**OTHER CHANGE – OTH/2025/12**

776 PACIFIC PARADE, CURRUMBIN JOB – 2130201

RE: RESPONSE TO INFORMATION REQUEST 776 PACIFIC PARADE, CURRUMBIN, QLD 4223

Cozens Regan Group Pty Ltd has provided the following responses to the relevant queries raised in City of Gold Coast's Information Request (issued to John Fuglsang Developments Pty Ltd, dated 10/04/2025) related to the Material Change of Use application at 776 Pacific Parade, Currumbin.

CONCEPT ENGINEERING PLANS

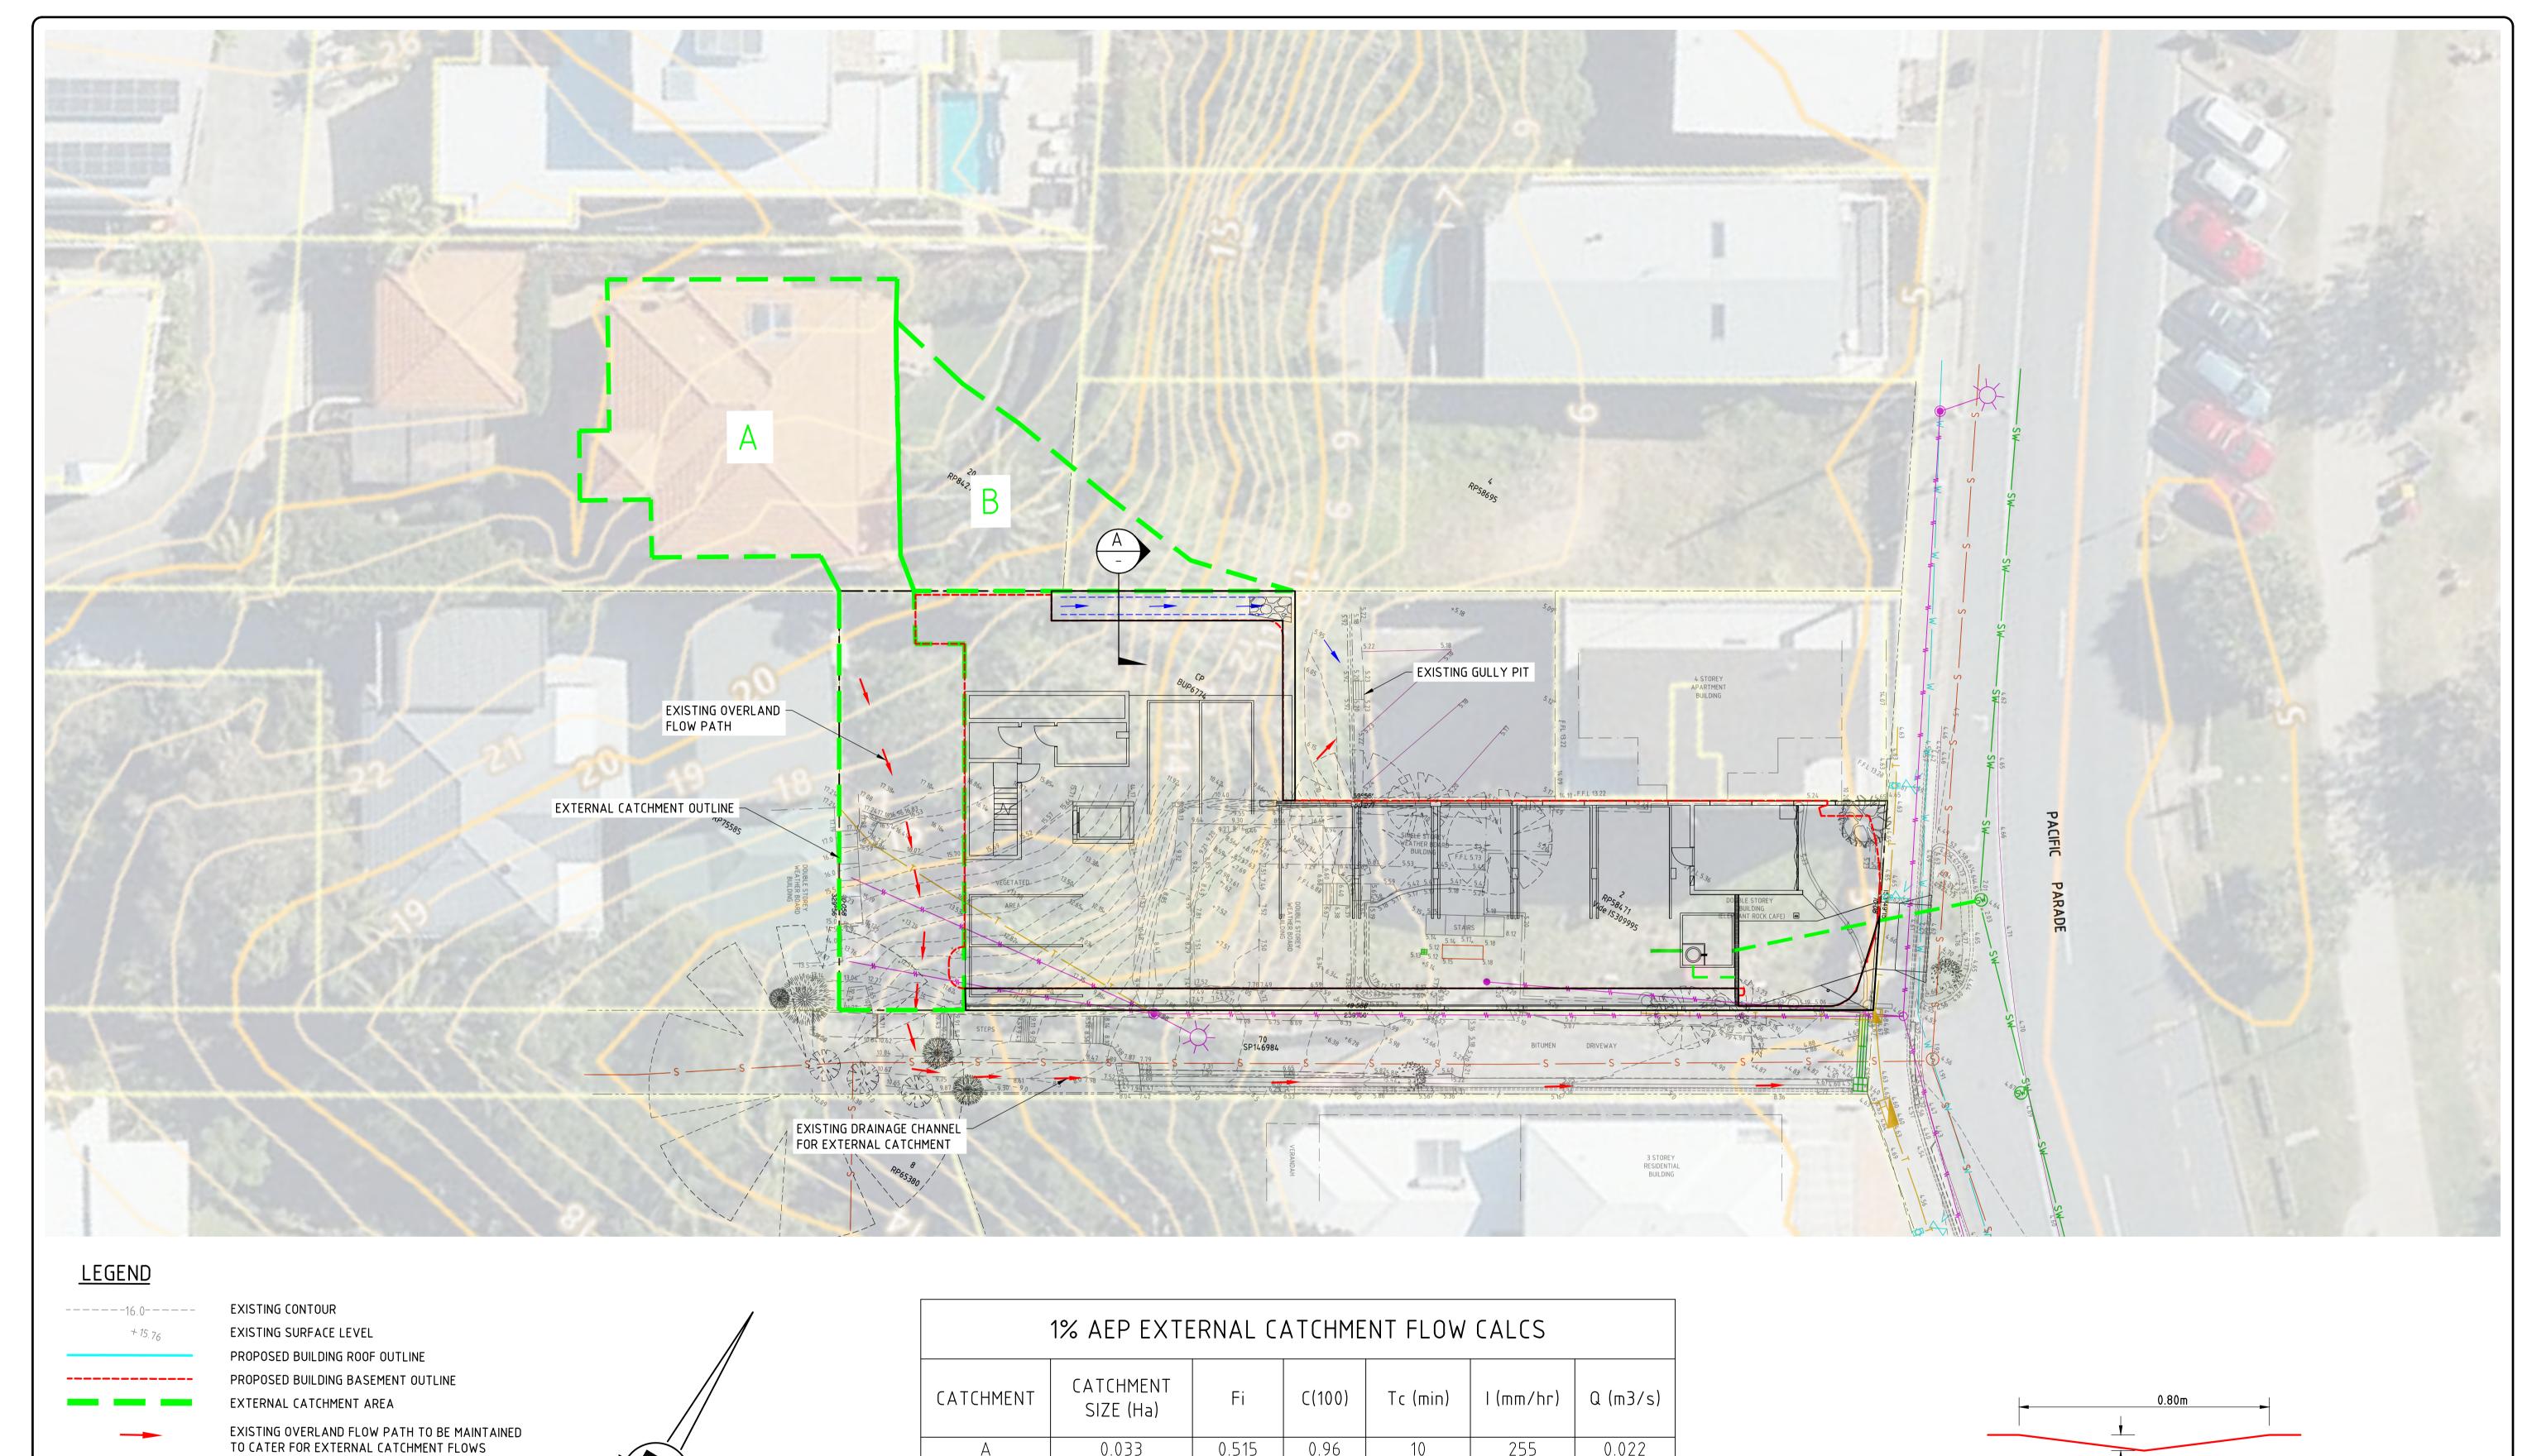
- The above-ground O.S.D. tank is no longer proposed. Please see updated drawings 220627/SK02 & SK04 which show the updated proposal for stormwater detention.
- The Stormwater Quantity Calculations show that the increase in peak runoff flow rates is very small (maximum of 4 l/s for 2% AEP event), and so a minimum detention allowance of 2m³ has been proposed and will be sufficient to cater for the negligible flow rate increase. Therefore, no modelling software has been used.
- Please refer to the updated Stormwater Management Plan Report.

- Please refer to the updated External Catchment Plan (220267/SK03).
- The overland flow path through the rear of the property is existing. In our opinion, the
  development will not increase the flow through this existing overland flow path. Therefore, it
  is considered appropriate to maintain the existing conditions to the rear of the building to
  cater for External Catchment A.
- The drainage channel to the south of the property is existing. In our opinion, the development will not increase the flow through this channel. Therefore, it is considered appropriate to maintain the existing channel to cater for External Catchment A.
- A shallow V-channel and rock scour protection has been proposed to convey the minor flow from External Catchment B. See updated drawing 220627/SK02.
